Storm Water Inspection

Ciniza Refinery EPA Stormwater Inspection & OCD Follow-up from September 8, 2005 Inspection

November 10, 2005

POND FLOW DIAGRAM

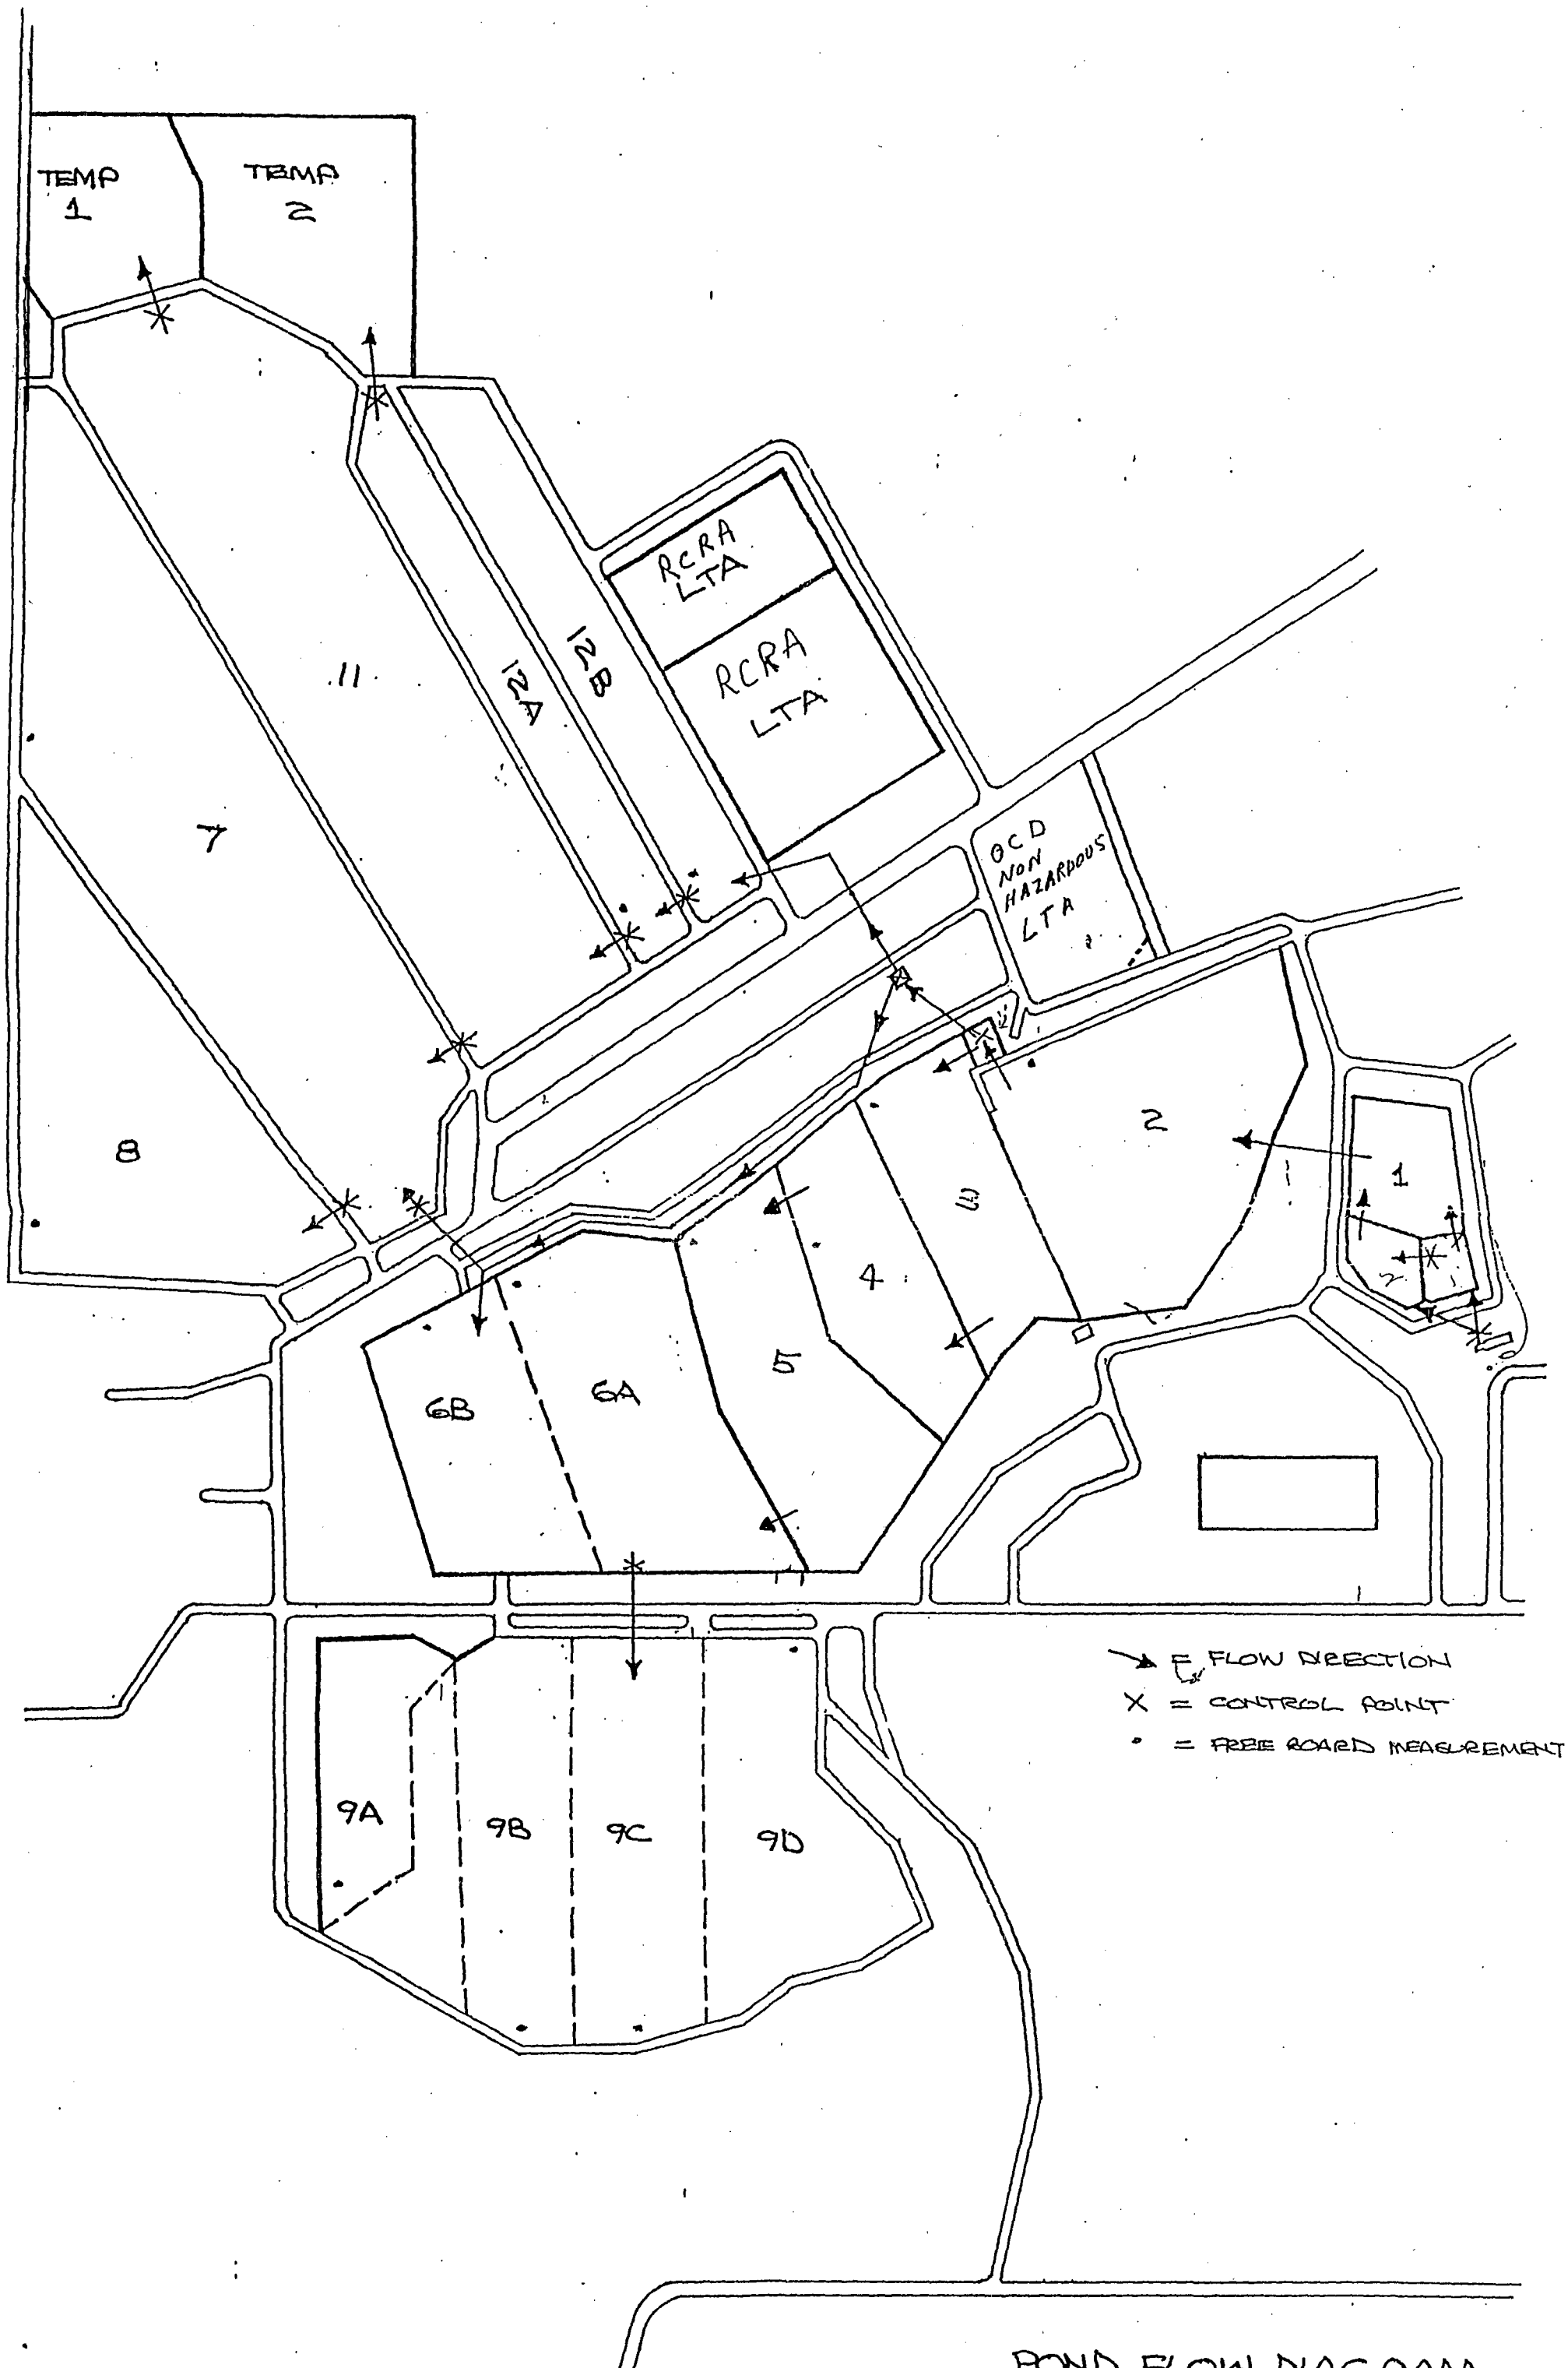
- 13) OCD split-samples with SM from the Old API Separator (OAPIS), the discharge point from Aeration Lagoon 2 to Evaporation Pond (EP) #1, and discharge point from EP #1 to EP #2. OCD is currently awaiting receipt of the analytical sample results from Hall Environmental of Albuquerque. OCD followed all chain-of-custody procedures up to and including delivery to the laboratory the next morning.
